# Traffic Calming on Osborne and River

April 9, 2024

## Addressing the Motion from Council

## Protected Intersection

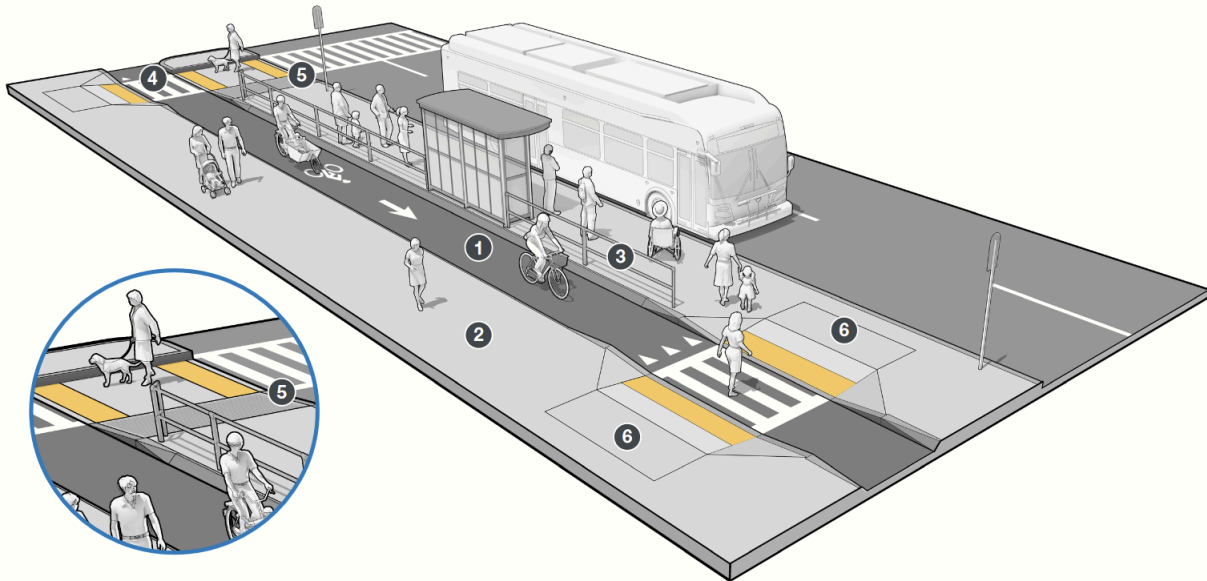
A first suggestion to improve safety and convenience of prioritization of pedestrians and people on bikes at this intersection would be to remove the right turn lane on River Ave approaching Osborne. This would:

- Allow the bus stop to remain at the corner of River and Osborne rather than be backed up to the start of the right turn lane.
- Reduce the risk of right hook collisions with people on bikes heading across Osborne St
- Reduce the crossing distance of River Ave
- Provide a second ramped entrance to the bus platform
- Square up the crossing of Osborne on the north side of River

We ask that a protected intersection be implemented as part of the River/Stradbrook protected bike lanes project to reduce the right turn conflict at the corner of River and Osborne St. Efforts to reach out to organizations serving people with visual impairment, as well as organizations serving people with mobility challenges should be included in the project.

## EXHIBIT 5J: FLOATING BUS STOP (INTERSECTION)

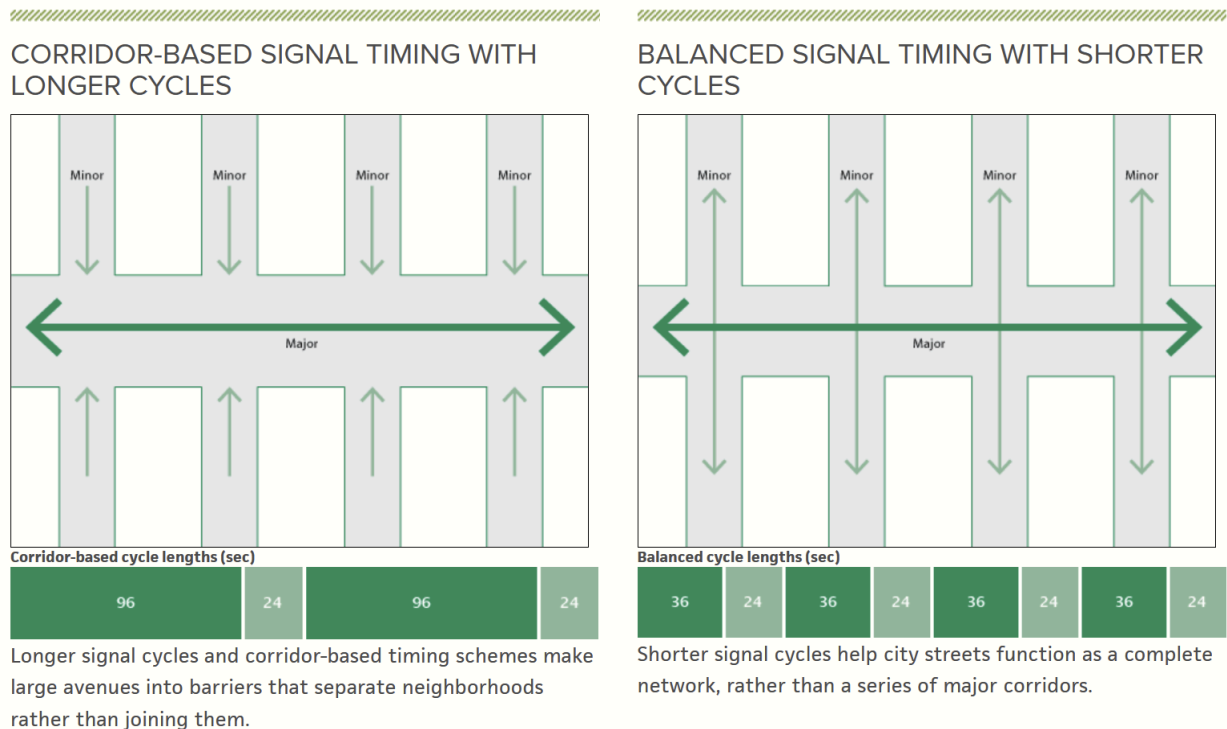
The MassDOT Separated Bike Lane Planning & Design Guide, a well-respected design guideline for protected bike lanes, provides excellent advice on the integration of protected bike lanes and bus stops.

Figure 4.6. Smart channel protected corner

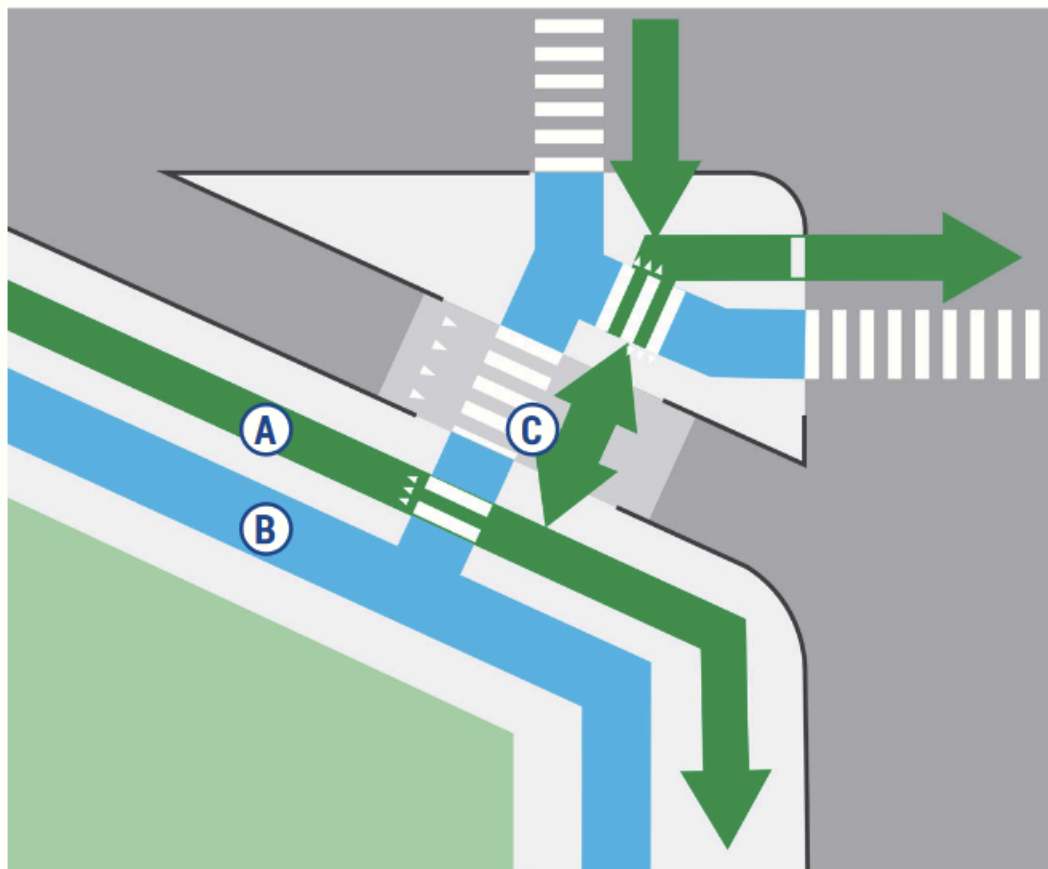
While the report recognizes continuous sidewalks as an intervention having a “positive outlook” to be reviewed as part of an upcoming update to the Transportation Standards Manual, it makes no recommendations to include even a pilot for such an intervention here, despite the direct call for such a pilot in the motion that triggered this study.

Cities such as Edmonton are making wide use of continuous sidewalks as part and parcel of their regular maintenance work. Guidance on Smart Channels, as provided in the City of Ottawa’s Protected Intersection Design Guide clearly calls for the inclusion of continuous sidewalks as part of Smart Channel design as well. Indeed, the Osborne Village Secondary plan also calls for the use of Raised Crossings.<sup>5</sup>

We ask that a pilot of a continuous sidewalk be implemented as part of the River/Stradbrook protected bike lanes project. Efforts to reach out to organizations serving people with visual impairment, as well as organizations serving people with mobility challenges should be included in the project.
